RE: Incomplete Determination of the 2020 Groundwater Sustainability Plans Submitted for the San Joaquin Valley – Kaweah Subbasin

**STATEMENT OF FINDINGS REGARDING THE
DETERMINATION OF INCOMPLETE STATUS OF THE
SAN JOAQUIN VALLEY – KAWEAH SUBBASIN
GROUNDWATER SUSTAINABILITY PLANS**

State of California
Department of Water Resources
Sustainable Groundwater Management Program
Groundwater Sustainability Plan Assessment Staff Report

Groundwater Basin Name: San Joaquin Valley – Kaweah Subbasin (No. 5-022.11)
Number of GSPs: 3 (see list below)
Number of GSAs: 3 (see list below)
Point of Contact: Eric Osterling
Recommendation: Incomplete
Date: January 28, 2022

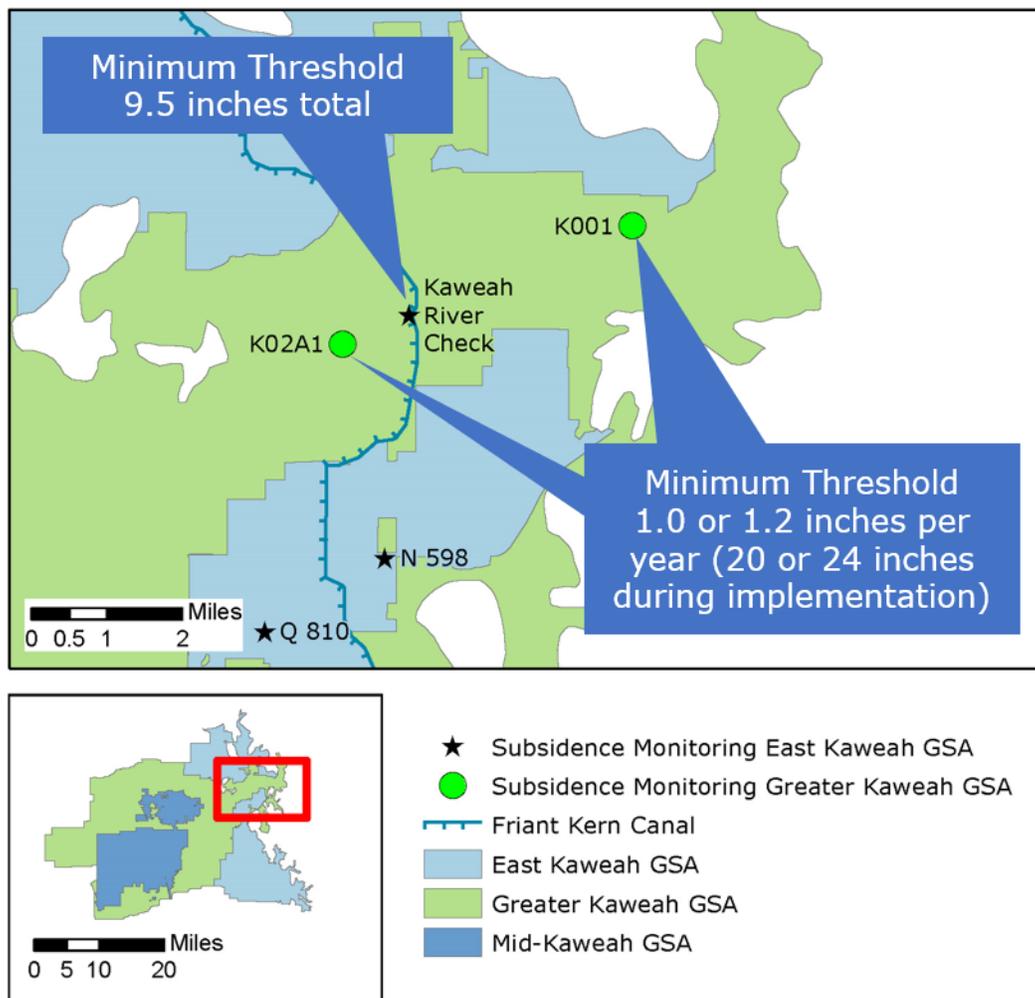
The differences between Greater Kaweah and East Kaweah GSPs creates the potential for inconsistency in groundwater management between the Subbasins GSPs. A portion of the Greater Kaweah GSP area bisects the East Kaweah GSP area in the vicinity of the Friant Kern Canal (see Figure 1).

Greater Kaweah’s subsidence minimum thresholds in this area allow for 1.0 to 1.2 inches per year of subsidence, or 20 to 24 inches cumulatively over the 20-year implementation period. Neither the East Kaweah nor the Greater Kaweah GSPs nor the Kaweah Subbasin Coordination Agreement explain how up to 24 inches of subsidence in the Greater Kaweah area can be accommodated without interfering with the 9.5-inch limit set by East Kaweah to protect the conveyance capacity of the Friant-Kern Canal. The GSPs will need to reconcile this apparent discrepancy. (See Corrective Action 2b.)

- b) Following changes to the GSPs described in Corrective Action 2a, Greater Kaweah also must explain how their minimum thresholds in the vicinity of identified critical infrastructure (i.e., the Friant Kern Canal) will not substantially interfere with the Canal's use (identified by East Kaweah GSA as an undesirable result). Address how the amount of potential cumulative subsidence allowed for by Greater Kaweah's subsidence rates, which currently exceeds the amount identified by East Kaweah that would cause an undesirable result, are compatible or provide revised rates for the eastern portion of the Subbasin that are compatible.
